TCEP Project No.: 097-039-15
LPS Bid No.: 8365

ADDENDUM NO. 1

Project:	LPS Humann Elementary Renovation
Project Number:	097-039-15
Meeting Date:	2/23/2016
Meeting Time:	4 PM
Meeting Location:	LPS Humann Elementary

NOTE:
 MAINTAIN 4'-0" CLEAR AND 7'-6" HEADROOM IN WALKWAY OF ALL EQUIPMENT, PIPING, AND DUCTWORK. IF SPACE IS NOT OBTAINABLE, MECHANICAL CONTRACTOR IS TO NOTIFY GENERAL CONTRACTOR WHO SHALL NOTIFY ENGINEER AND LPS FACILITIES BEFORE INSTALLATION.

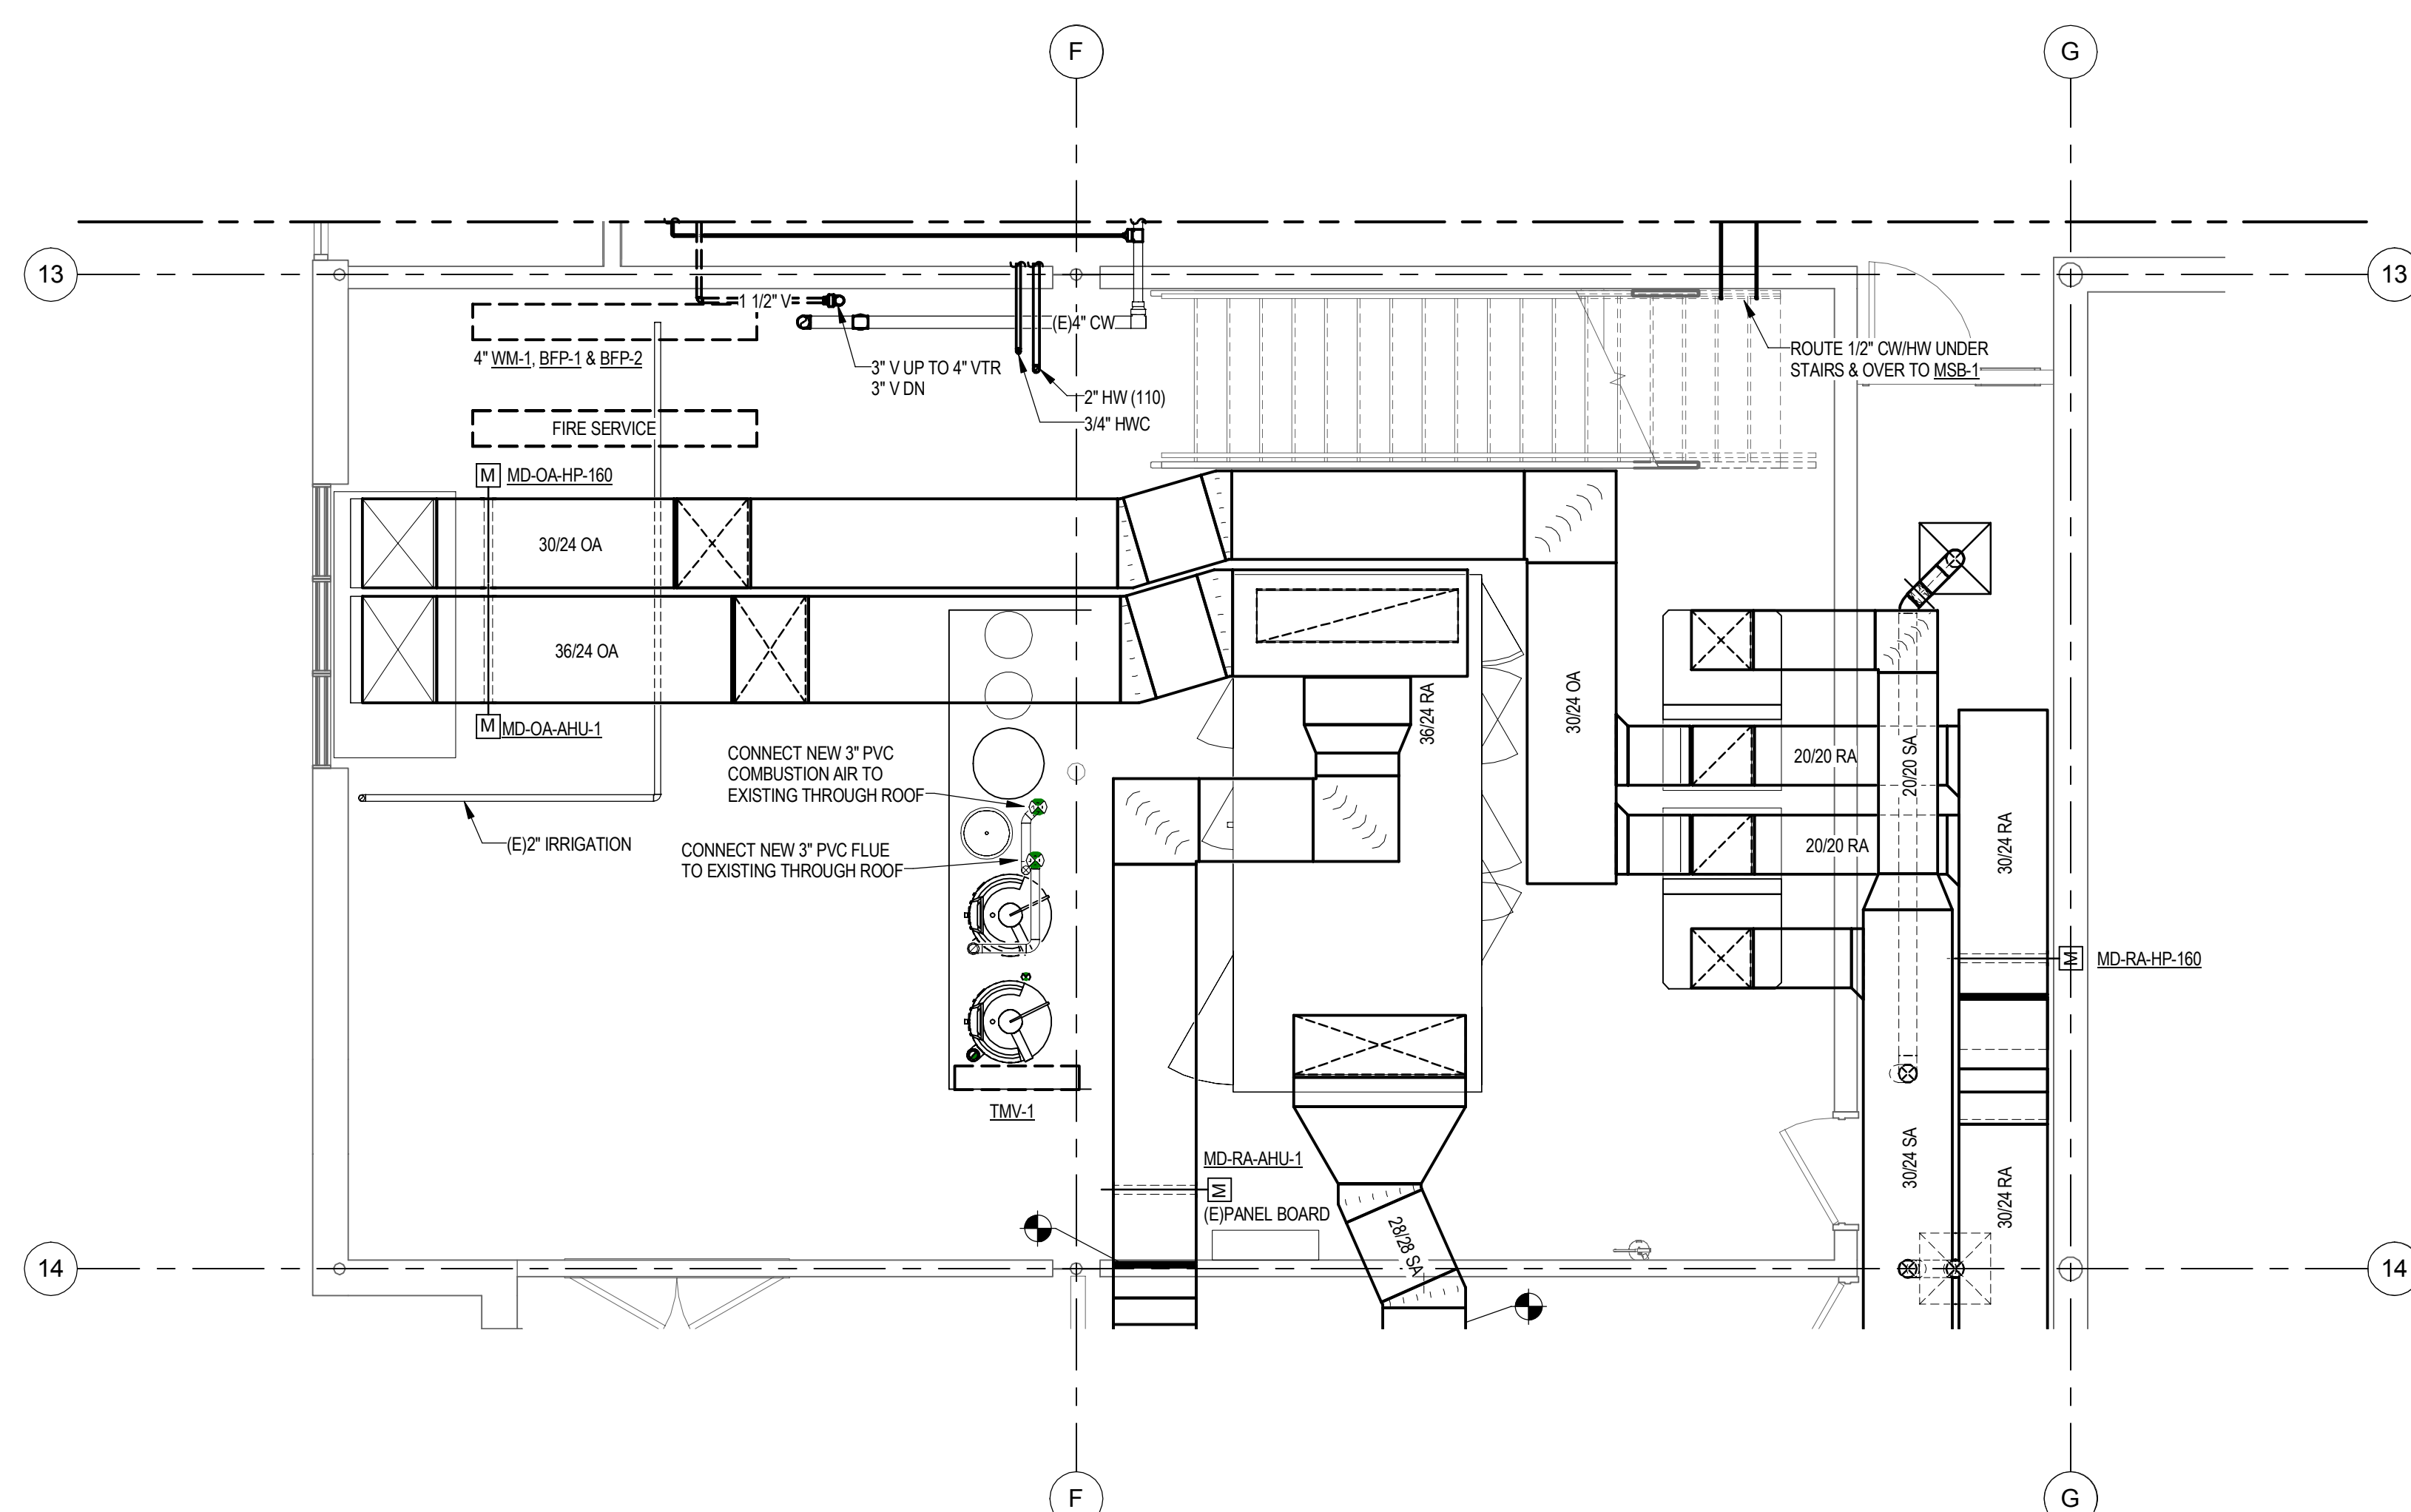
Sheet has been resubmitted showing new layout for AHU-1 unit.
